Request For Further Information

Proposed Cemetery Development

City West, Saggart, County Dublin.

Planning Ref: SD22A/0457

Figure showing Perched Water Levels

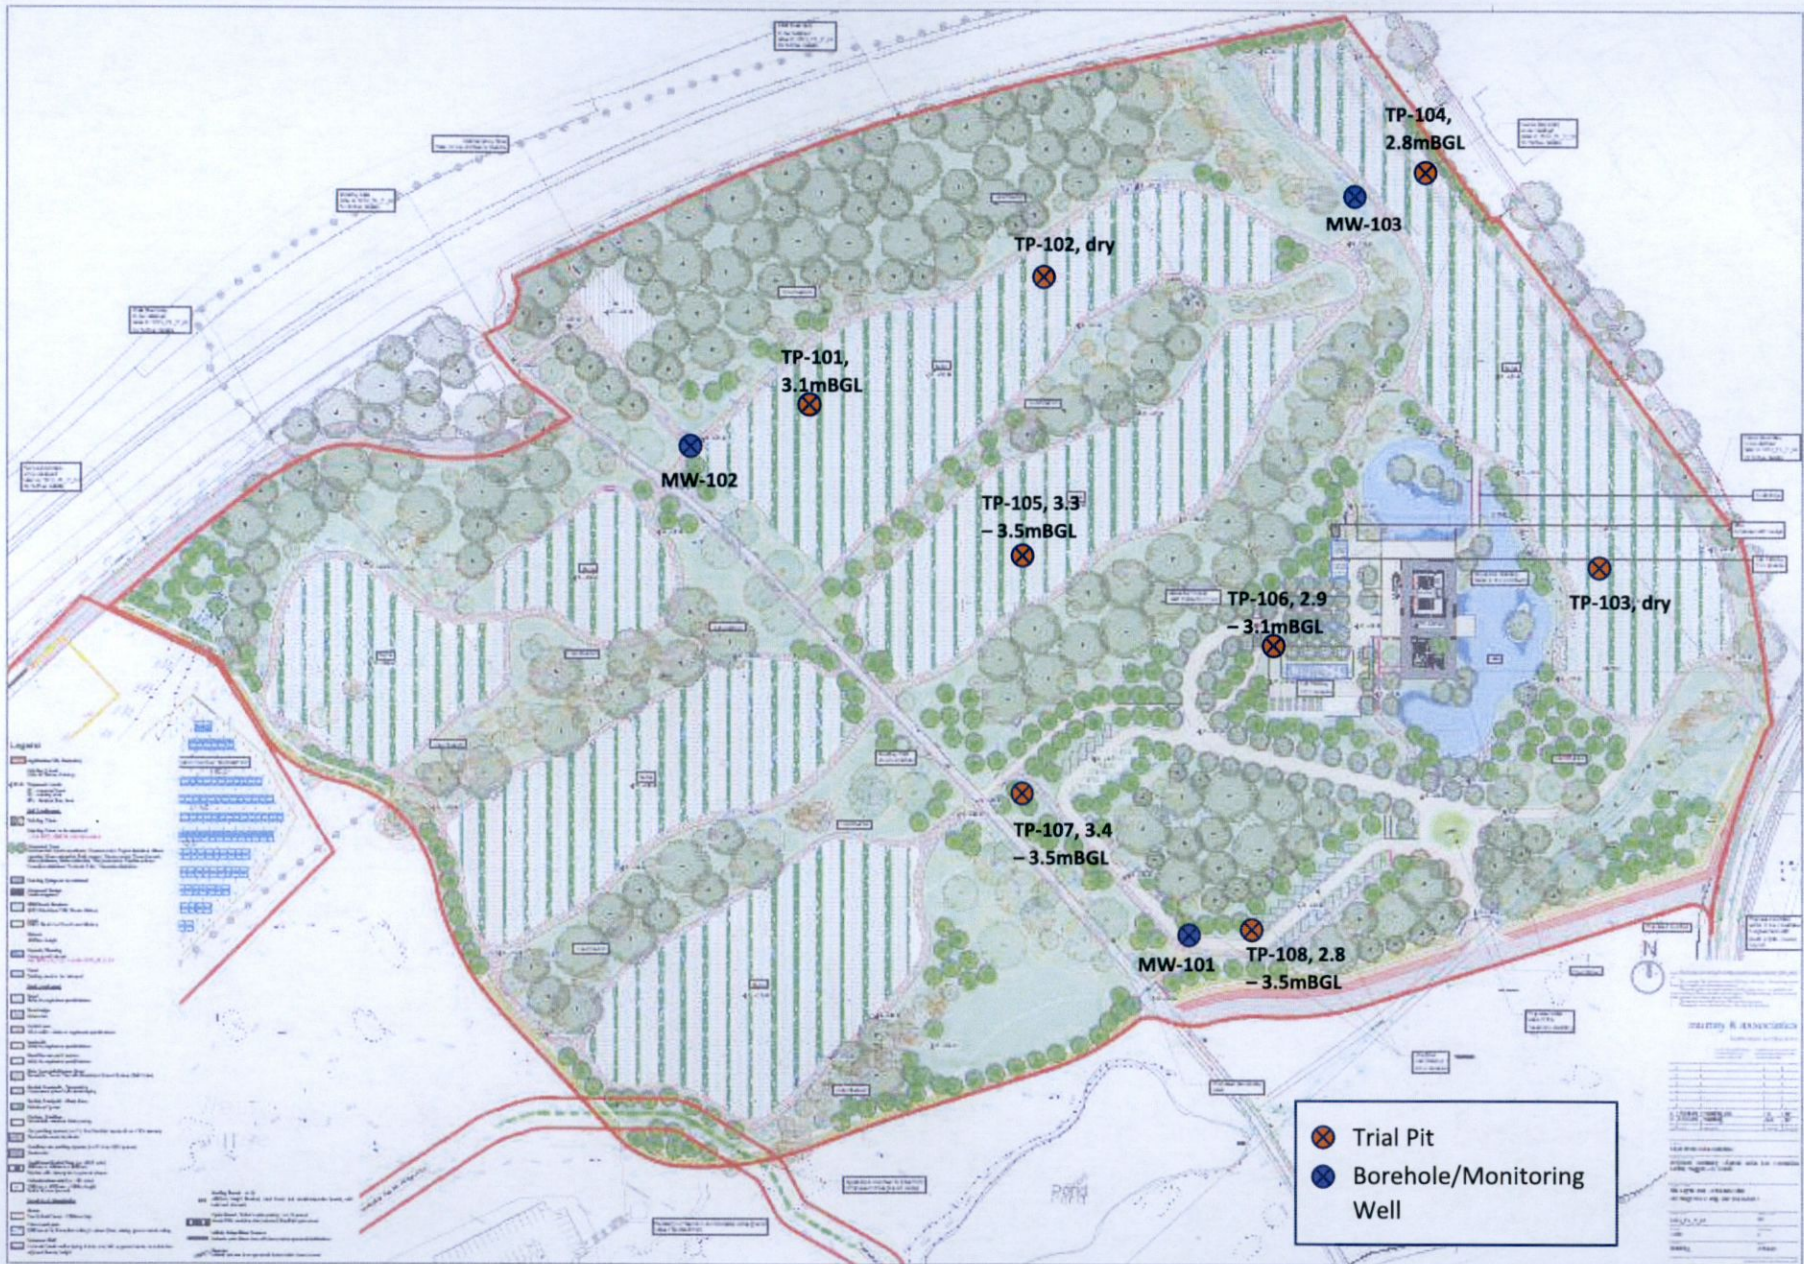
(ii) The applicant is requested to provide a site drawing that overlays the interment locations with ground water depths

Groundwater levels illustrated on attached figure.
